Keresley Link Road

Keresley Parish Council objects to the plan put forward for the construction of 323 houses by Taylor Wimpey in RMM/2019/1030 for the following reasons:

Keresley Parish Council objects to the Taylor Wimpey planning application RMM/2019/1030

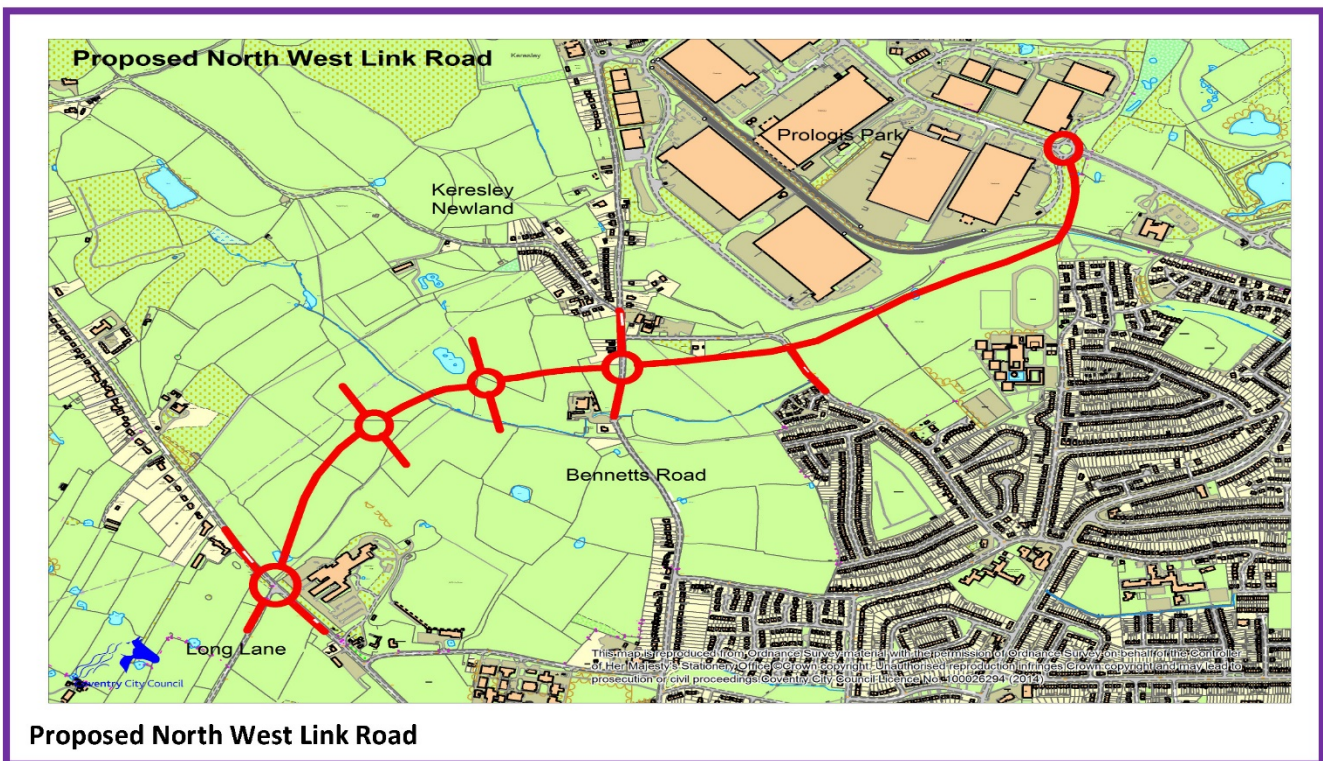
A large proportion of this proposed Link Road is shown running through land owned by Queens College Oxford. The current Reserved Matters planning Application from Taylor Wimpey, RMM/2019/1030, does not include the land owned by Queens College Oxford that was shown in the outline application.

Without the Queens College Oxford being available for the Keresley SUE the link road cannot be built, thus making the building of 3100 dwellings un-sustainable!
